RigiCloud Release Notes - 1.20

Date: September 4, 2026

Quarterly release - 2026-09-07

RigiCloud and Edge Node - v1.20.0:

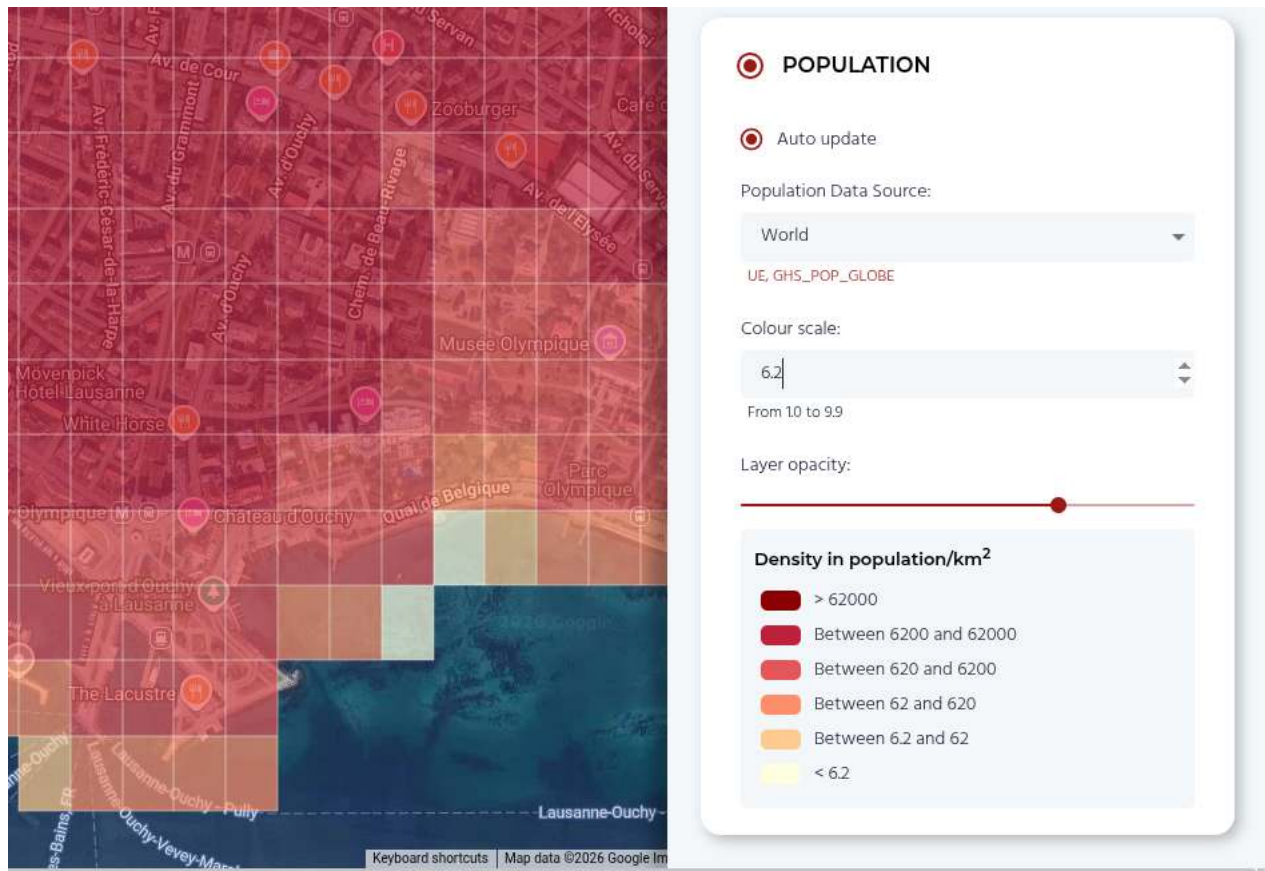
- **Improved Control Tower mission awareness:**
 - The current target position is now always visible, so operators can see where the drone is heading.
 - The current target rally-point is highlighted and refreshed every five seconds, making the next destination clear before an SRP action is taken.
- **Population-density map controls:** Operators can adjust the population-density scale in the map to better assess route risk.
